## **HOTEL COMPANY OF MOBILE SUBDIVISION**

The plat illustrates the proposed 2.6 acre<sup>±</sup>, 1 lot subdivision which is located at 840 West I65 Service Road South (West side of West I65 Service Road South, extending to the South side of Western America Drive, and extending to the East side of Western America Circle). The subdivision is served by city water and sanitary facilities.

APPLICATION NUMBER 20 DATE February 5, 2004  
APPLICANT Hotel Company of Mobile Subdivision  
REQUEST Subdivision

# HOTEL COMPANY OF MOBILE SUBDIVISION

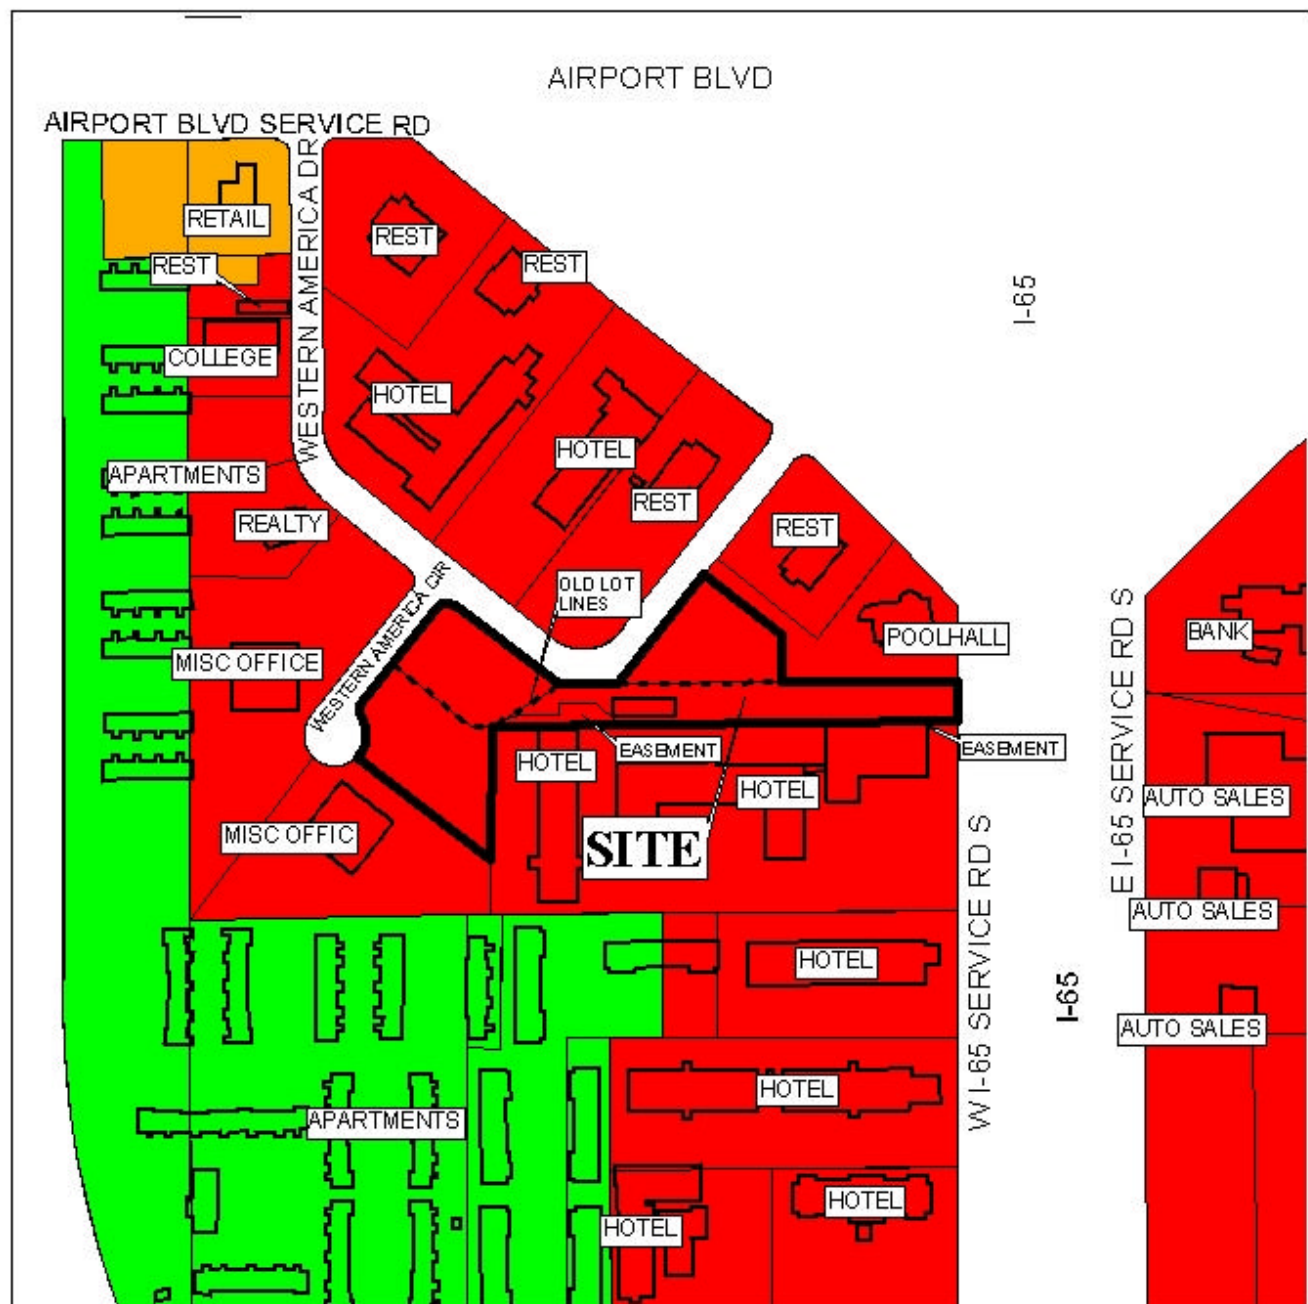
The proposed site would be very irregularly shaped and have street frontage on four sides. Two of the frontages would be at a 90° angle in the road, and thus should not be allowed access within this area.

Also, as indicated on the plan, the adjacent motel has a drive and several parking spaces located within this site. There is however, no shared access proposed; the developments will be completely separate. An easement for the encroachment of the drive and parking facilities has been granted.☞

The plat meets the minimum requirements of the Subdivision Regulations and is recommended for Tentative Approval, subject to the following conditions: 1) placement of a note on the final plat stating that site is limited to one curb cut to Western America Circle, location and design to be approved by Traffic Engineering; 2) placement of a note on the final plat stating that the site is limited to one curb cut to Western America Drive, approximately midway between Western America Circle and the 90° angle in the road, exact location and design to be approved by Traffic Engineering; 3) placement of a note on the final plat stating that the site is limited to one curb cut to West I65 Service Road S, exact location and design to be approved by Traffic Engineering and ALDOT; 4) the easement for the existing drive and parking be shown on the final plat, and the placement of a note on the final plat stating that there shall be no access connection between the properties; and 5) submission of an administrative PUD to consent to the parking and drive encroachment.
